DTB Date: December 22, 2005

Order No.: P-B-15.30/55a

Revision: Addition of Model 211 and Applicable Procedure

Engine Not Starting / Starter Fuse Malfunctioning

Figure 1 P-B-15.30/55a

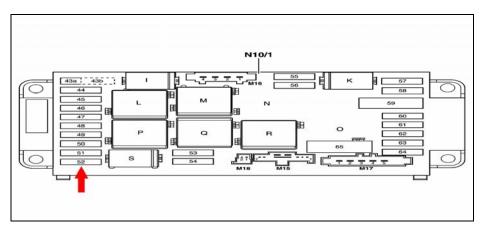
- Perform a visual inspection of the Driver SAM (N10/1) and determine which fuse is installed in socket 52 (Figure 1, arrow). Consult STAR Finder for more information on the location of this fuse (10/1f52).
- 2. Replace the currently installed 15 Amp fuse with the 20 Amp fuse specified in this DTB.
- 3. Record the fuse rating change on the vehicle's Fuse Chart.

Figure 2 P-B-15.30/55a

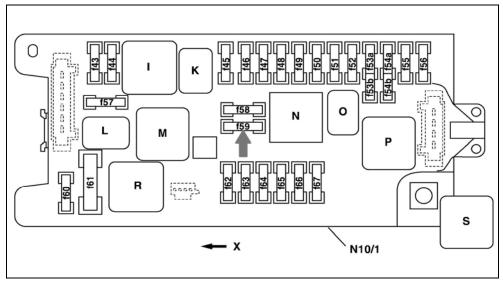
- 1. Perform a visual inspection of the Driver SAM (N10/1) and determine which fuse is installed in socket 59 (Figure 2, arrow). Consult STAR Finder for more information on the location of this fuse (10/1f59).
- 2. Replace the currently installed 15 Amp fuse with the 20 Amp fuse specified in this DTB.
- 3. Record the fuse rating change on the vehicle's Fuse Chart.
